# Access Compliance Report

## Public Rights-of-Way

Intersection ID: 22250	Main Street: SHARON_LAKES_RD	Cross Street: SOUTH_BV	Location: NW
ADA ID: 85BF8C5C4FE9	Ramp Type: Perp	Initial Pass/Fail: Fail	Overall Compliance: No
		Severity Score: 35

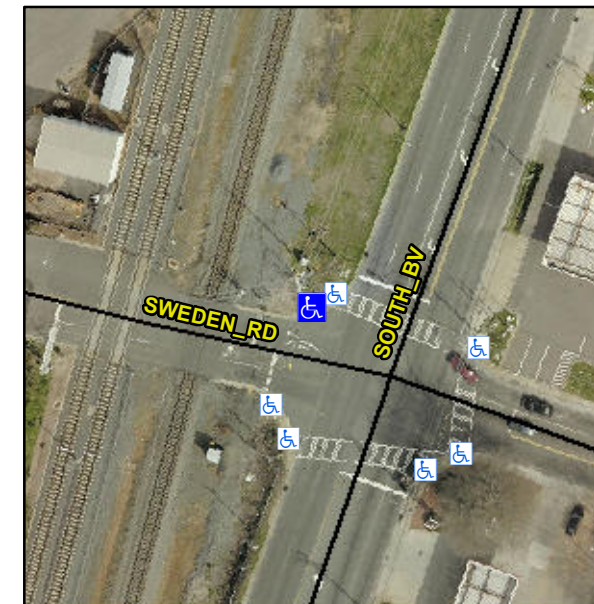
**Not Found, R304.5.1, R304.2.2**

Compliance	Description	Data	Compliance	Description	Data
N/A	Ramp Length (in)	48.0	No	Ramp Slope (%)	12.0
No	Ramp Width (in)	38.0	Yes	Ramp XSlope (%)	3.6
N/A	Flare Type LT	N/A	N/A	Flare Type RT	N/A
N/A	Flare Slope LT (%)	N/A	N/A	Flare Slope RT (%)	N/A
N/A	Flare Traversable LT?	N/A	N/A	Flare Traversable RT?	N/A
N/A	Landing Length (in)	N/A	N/A	DWS Provided?	N/A
N/A	Landing Width (in)	N/A	N/A	DWS Contrast?	N/A
N/A	Landing Slope (%)	N/A	N/A	DWS Length (in)	N/A
N/A	Landing X Slope (%)	N/A	N/A	DWS Full Width?	N/A
N/A	Landing Curb? (Y/N)	N/A	N/A	DWS Offset (in)	N/A
N/A	Shared Landing?	N/A			
N/A	Gutter Ponding?	N/A	N/A	Gutter Slope (%)	N/A
N/A	Gutter Lip Ht (in)	N/A	N/A	Gutter X Slope (%)	N/A
N/A	Painted X Walk1?	No	N/A	Painted X Walk2?	N/A
	X Walk 1 Direction	To SW		X Walk 2 Direction	N/A
N/A	X Walk 1 Width (in)	N/A	N/A	X Walk 2 Width (in)	N/A
	X Walk 1 Slope (%)	0.0		X Walk 2 Slope (%)	N/A
	X Walk 1 X Slope (%)	4.8		X Walk 2 X Slope (%)	N/A

**Remove & Replace Entire Ramp.**
